CALL NO. 110
CONTRACT ID NO. 151015
ADDENDUM # 2

Subject: Spencer County, STP BRO 5125 (011)
Letting April 24, 2015

I am returning two copies of an approved permit (Reference Number 2013008.TAY) for the proposed KY55 at Salt River Replacement Bridge project. The new bridge will be located approximately 100 feet east (upstream) of the existing bridge and will require excavation of the levee to about elevation 501.3 feet at approximate Levee Station 4+96, to accommodate the new roadway alignment.

Standard Operating Procedure for Benching and Compaction for Levee and Floodwall Modifications

AS BUILT
630-12.2/7.1
EXHIBIT B

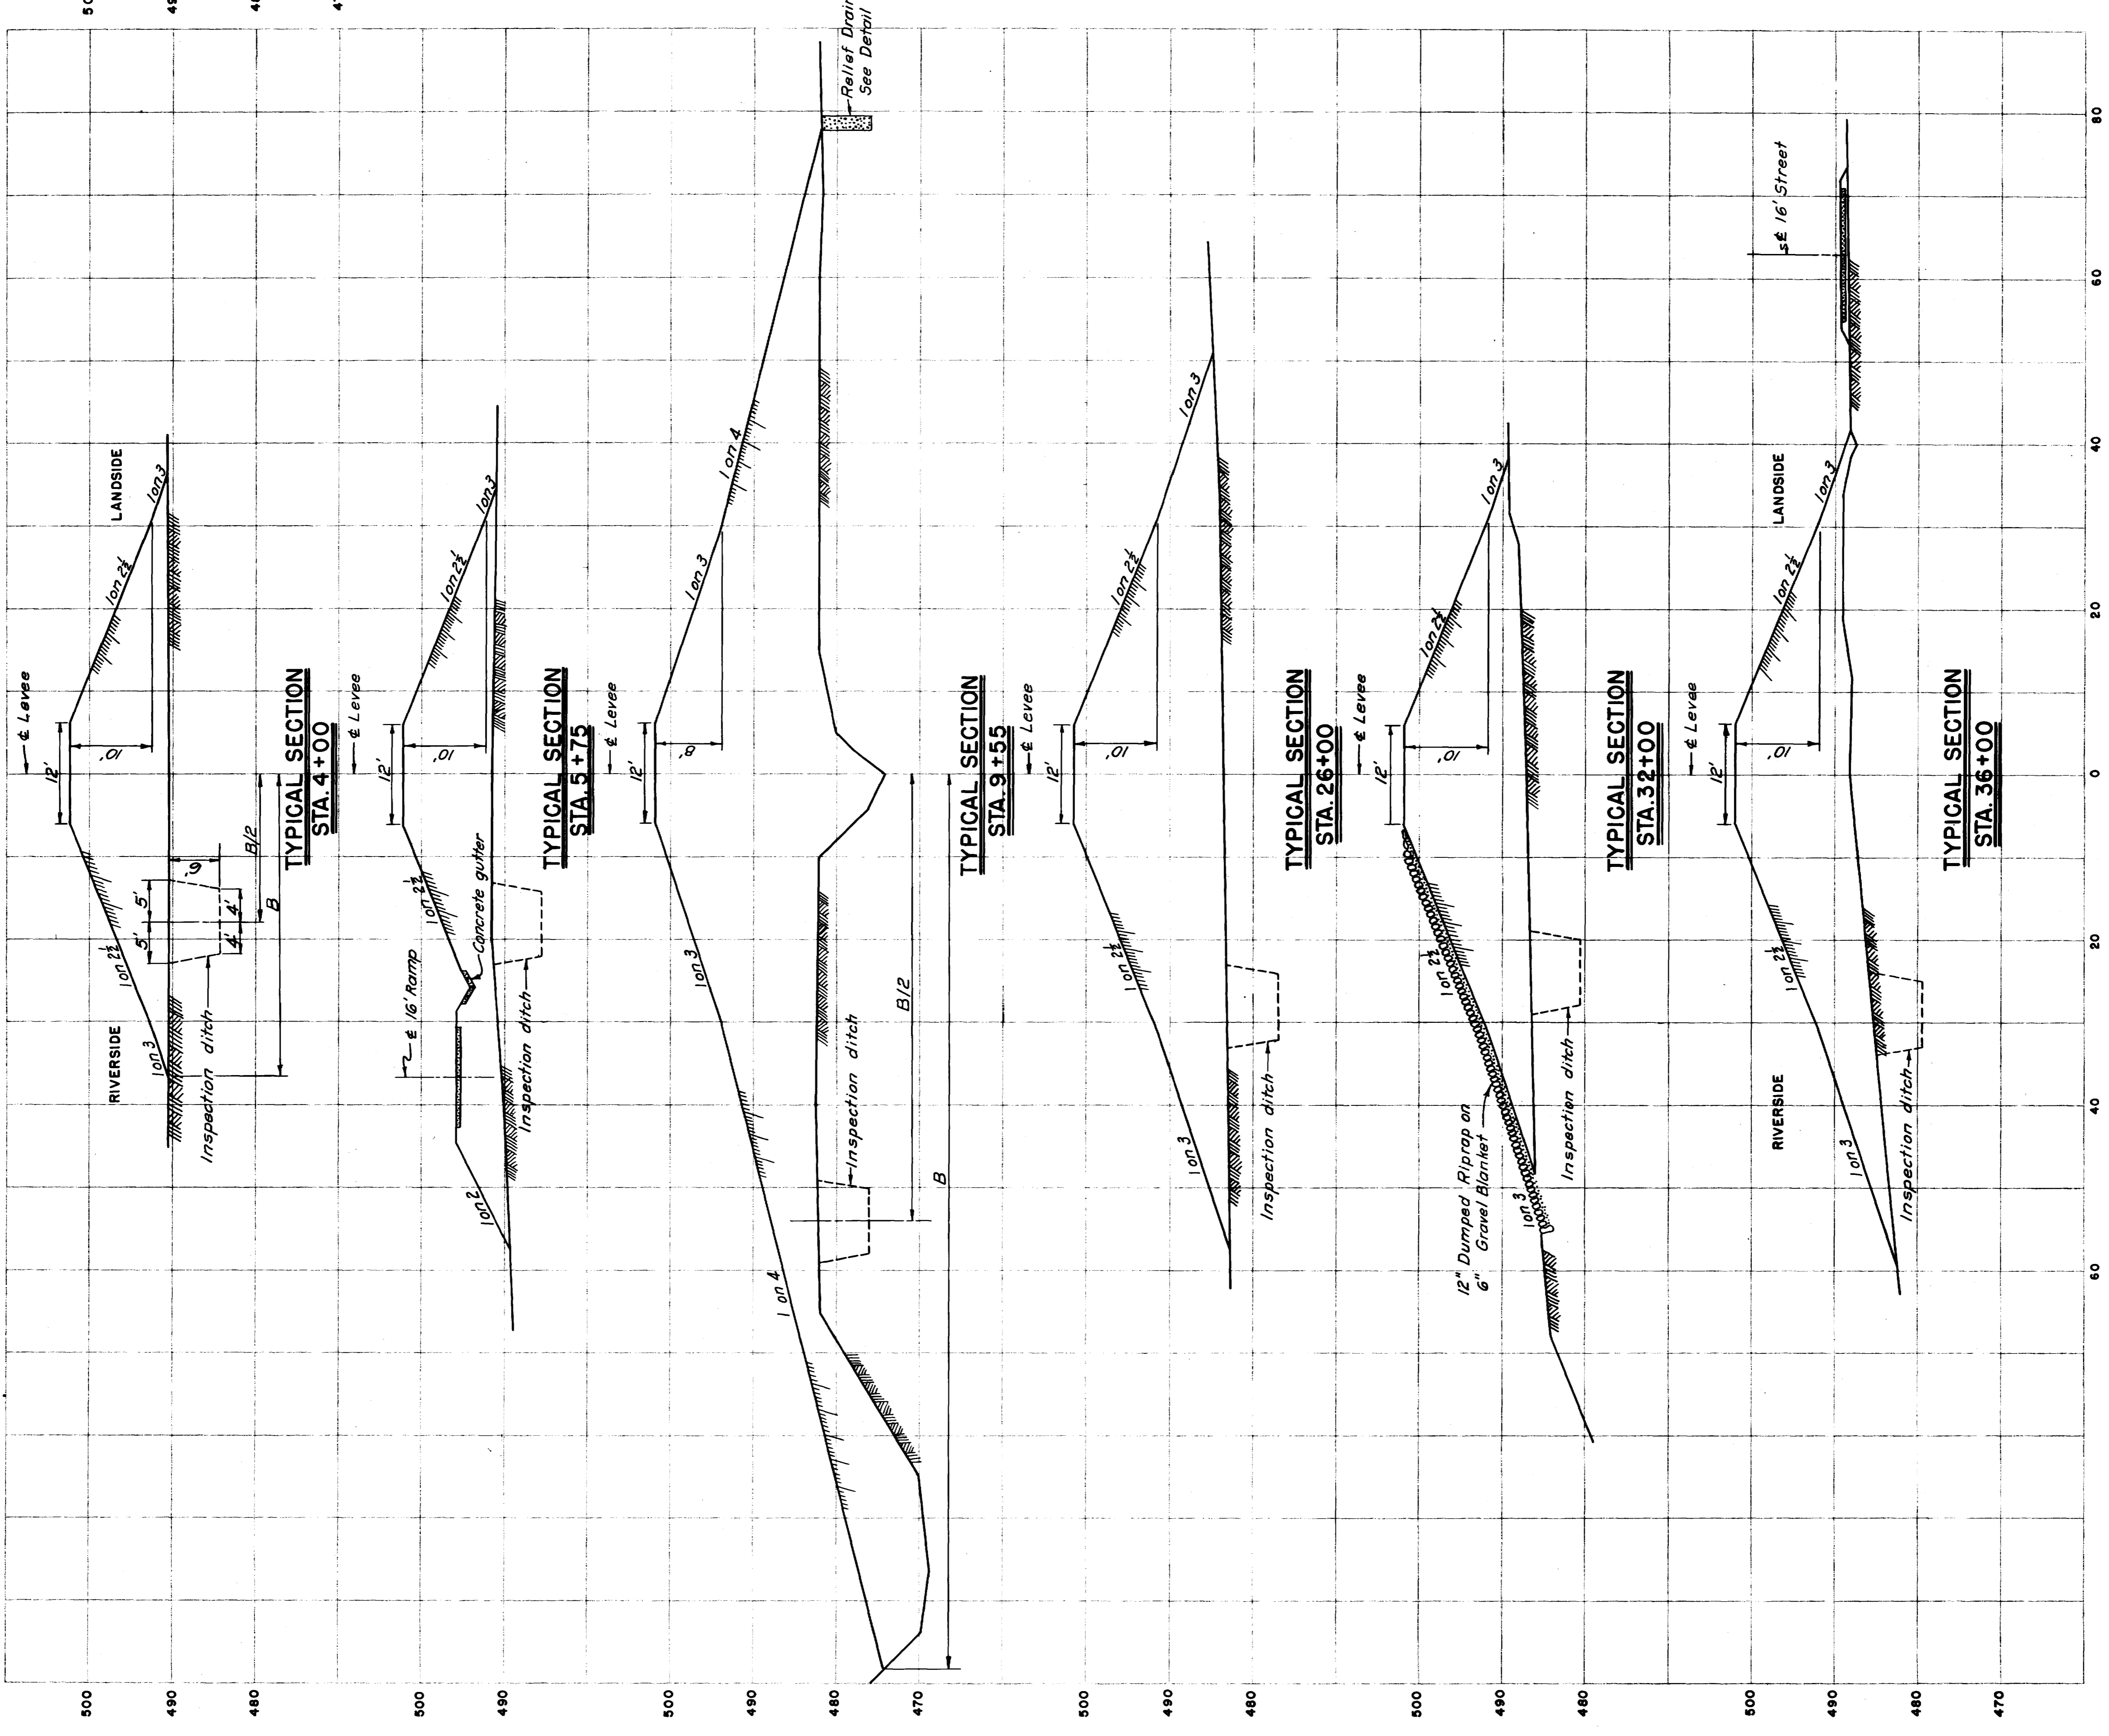
****NOTE: Please make sure that the KTC closes the opening in the levee at the existing sandbag closure. The fill should be benched into the levee to the design configuration (see attached) and the fill should consist ONLY of low permeability (CL type) soil.

a. The existing roadway pavement and/or deleterious materials (to include aggregate base) located at Levee Station 6+38 (existing sandbag closure) shall be completely removed within 15 feet of the levee toe limits, and the levee restored to its design configuration as shown on As-Built Drawing No. 630-12.2/7.1, Typical Section Detail at Station 5+75. All fill material shall consist of low permeability soils – impermeable soils (e.g. SC, CL or CL-ML with an estimated hydraulic conductivity less than 1×10^{-6} cm/sec) and be placed in accordance with the Standard Operating Procedure (SOP) *Benching and Compaction for Levee and Floodwall Modifications* attached herein and available from the Louisville District's levee safety website: <http://www.lrl.usace.army.mil/lsp>.
